SERVICE BULLETIN No. 11/09/2010

Check of Ripcord Handle Pins

**SERVICE
BULLETIN**

Pic. 1
Ripcord Handle U-064

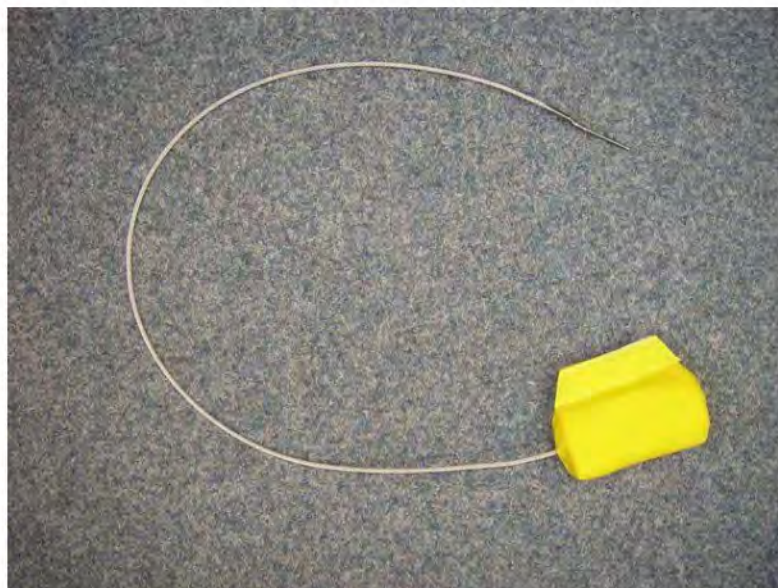
- 1. APPLIESTO:** the pins of ripcord handle reserve parachutes U – 064 (pic.1), U – 051 (pic.2) and U – 069 (pic.3), produced by Synek company (pressed pins – hexagonal press, see pic. 4 A - straight and pic. 4 B - bent), which are parts of:

- 2. REASON:** During multiple tests for attestation of power for tearing off the ripcord handle it was found out gradual increase of the power beyond the permissible range that is defined by the regulation (22,2 to 97,9 N). During analysis of this situation it was found out that during the multiple tearing-off the ripcord handle the surface of the ripcord pin body can be damaged. This state can further cause an increase of power needed for tearing off the ripcord handle.

- 3. MEASURES:**
- A user or a packer licensed to pack the reserve parachutes (authorized person) proceeds a check of the ripcord handle pin at the products mentioned in part 1 and in case the pin body is found damaged, he/she puts the parachute set out of service.

- Further he/she sends a report with the type number of the ripcord handle and also the length of the ripcord handle at the type U-064 and U-051 to MarS a.s. Jevíčko to the fax number + 420 461 353 861 or to an E-mail mars@marsjev.cz.

- The producer sends the new ripcord handle to the user free of charge.
 - The user sends the original part of the ripcord handle back to the producer.
